**Plan Review
1311 Woodside Road, Redwood City**

To: Ruemel Panglao, Planning and Building Department
From: *AV* Julie Young, Senior Civil Engineer, Utilities-Flood Control-Watershed Protection Section
Date: December 13, 2018
Subject: Sewer Review, 1311 Woodside Road, Redwood City

Reason for Review: New Townhouses – PRE2018-00054

Plan Identification: Site Plan; 1311 Woodside Road, Redwood City; APN 069-311-250 & 340; Kier & Wright; Plans Submitted 11/29/2018

SITE PLAN / GROUND LEVEL PLAN

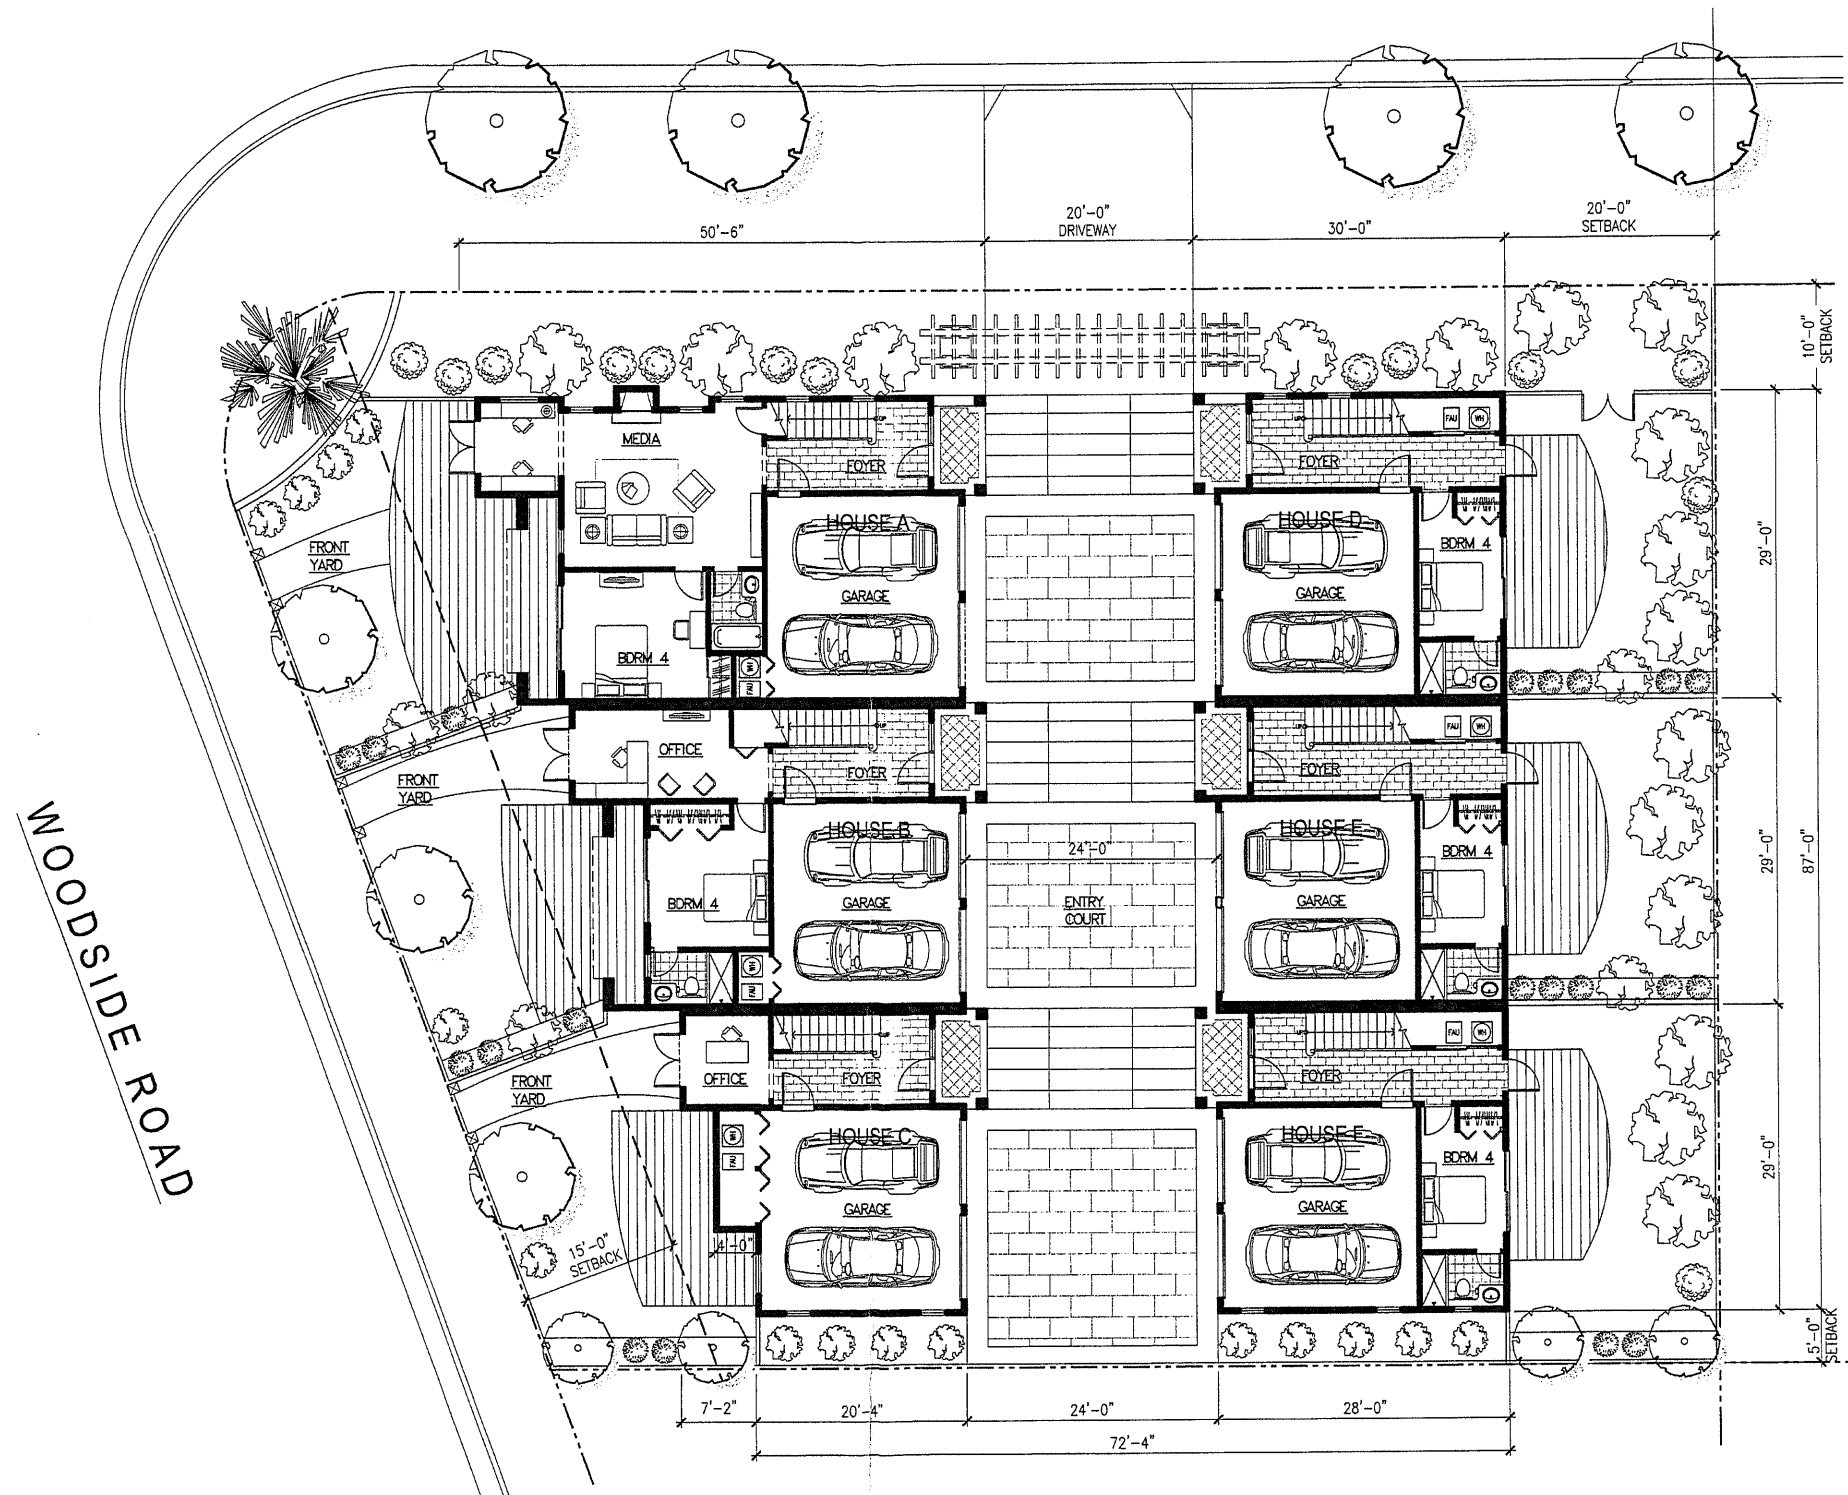
1. The site plan indicates that the two properties will be combined into one parcel. The Sewer District records indicate that the property has two existing sewer connections. The Sewer District will allow the proposed additional four (4) connections provided that all associated fees are paid. The Sewer District will require the applicant to purchase the additional sewer connections and obtain all appropriate permits for the installation of the connections. The fees for new sewer connections will be calculated based on the plans submitted prior to final approval of the building plans.

2. Detailed plans showing the proposed sewer connections shall be submitted to Sewer District for review prior to final approval of the building plans. The plans shall indicate the location of the existing and proposed sewer laterals.

3. The proposed parcel must connect to the Sewer District main with an individual 6" sewer lateral.
4. If multiple parcels will be merged into one parcel, please note that the Sewer District only allows one sewer lateral connection at its sewer main, and that other existing lateral connections must be removed, and the sewer mains repaired to the satisfaction of the Sewer District.
